**RESOLUTION SETTING HEARING ON REQUEST FROM TRINITY LAND HOLDINGS, LC FOR APPROVAL OF A PROPOSED 1<sup>ST</sup> AMENDMENT TO THE PAT BROKERAGE PUD CONCEPTUAL PLAN ON PROPERTY LOCATED AT 4529 DOUGLAS AVENUE**

Communication from the City Plan and Zoning Commission advising that at their January 20, 2022 meeting, the following action was taken regarding a request from Trinity Land Holdings, LC (owner), represented by Dennis Riordan (officer), for review and approval of a 1<sup>st</sup> amendment to the PAT Brokerage PUD Conceptual Plan on the property located at 4529 Douglas Avenue, to allow development of a 2.36-acre parcel along Douglas Avenue with a veterinary clinic use.

# AMENDMENT TO CONCEPTUAL PLAN FOR TRINITY LAND HOLDINGS LC

**TRINITY LAND HOLDINGS LC CONCEPTUAL PLAN**

PLAN MAP

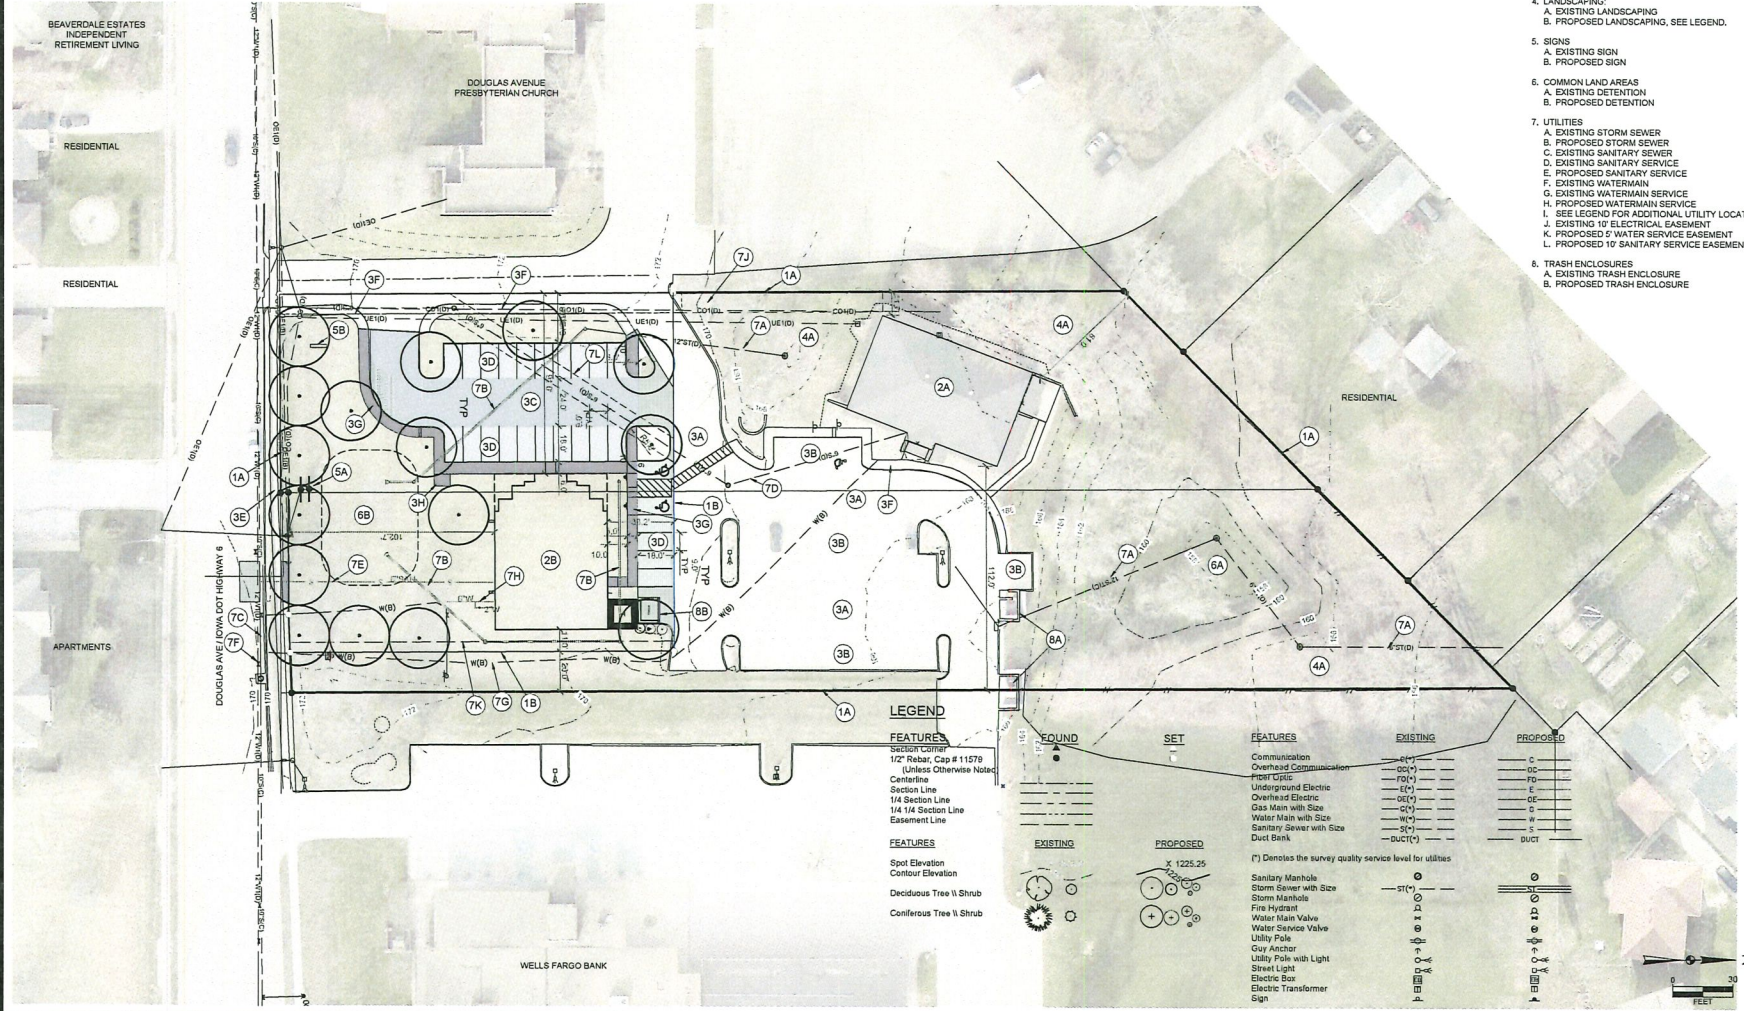
Staff believes the proposed PUD amendment is appropriate so long as the proposed structure engages Douglas Avenue by moving the building closer to the street so that it matches the setbacks of the buildings to the east and west, or is closer to the street than these two buildings. In addition, an entrance that faces Douglas Avenue should be provided.

- 6. Urban Design:** The proposed amendment includes a brick one-story structure, additional surface parking, and a stormwater system basin. The submitted site sketch indicates planting shade trees along the Douglas Avenue sidewalk (southern property line) with a stormwater basin north of the trees and open space between the basin and the proposed structure. The proposed structure would be located to the north of the open space and the adjacent existing parking spaces would be parallel to the northern façade of the proposed structure. The proposed main entrance would be located along the western façade adjacent to new additional surface parking. The proposed site sketch indicates the use of and coordination with the existing parking and drive aisle infrastructure. The proposed structure would have service entrances on the north and the east facades. The southern façade (Douglas Avenue façade) would contain two larger storefront type windows and 4 small service windows. The proposed building would include a hipped roof and building materials and design of a compatible nature to the existing building on the northern portion of the property.

Staff notes that the proposed site sketch locates the structure farther back from the primary street frontage than encouraged by the Planning and Design Ordinance. Staff understands that the proposal was designed as such to reassure neighboring property owners concerned with stormwater issues; however, City Engineering staff has determined that relocation of the stormwater system components would not be detrimental to the site or adjacent properties.

Staff believes that the proposed building should be moved closer to the street so that it matches the setbacks of the buildings to the east and west, or is closer to the street than these two buildings. In addition, an entrance that faces Douglas Avenue should be provided.

Justin Strom, Snyder and Associates, 2727 SW Snyder Blvd, presented a current PUD outline to demonstrate their reason for the placement of the building and storm water detention basin. The detention basin will be placed on the south side to provide an overflow path to Douglas Avenue, so it won't cause issues to the north during significant rain fall. They would like the setback requirements to be deviated from the staff recommendation to allow for a 10 to 15-foot setback from the north side of the basin instead of aligning with the existing buildings to the east and west. They will add an entrance feature on the south side of the building facing Douglas Avenue.

Johnny Alcivar asked if it would be possible to elongate the detention basin if they placed the building closer to the street.

Justin Storm stated that could be feasible, they would need to make sure there's enough room with the building closer to the street. The building has to be at least 10 feet away from the basin to avoid issues.

1. The building shall setback no further from Douglas Avenue than the existing building to the east and to the west, with the finalized setback determined with the PUD Development Plan.
2. Use of full-dimensional brick or other durable material as approved by the Planning & Urban Design Administrator.

- 3. Addition of the following notes on the "PUD" Conceptual Plan:
  - a) Development of the site must comply with the Tree Removal and Mitigation Ordinance contained in Chapter 42, Article X, of the City Code.
  - b) Any grading is subject to an approved grading permit and soil erosion control plan, as well as a Stormwater Pollution Protection Plan (SWPPP) approved by the Iowa DNR (ZONG-2021-000049)
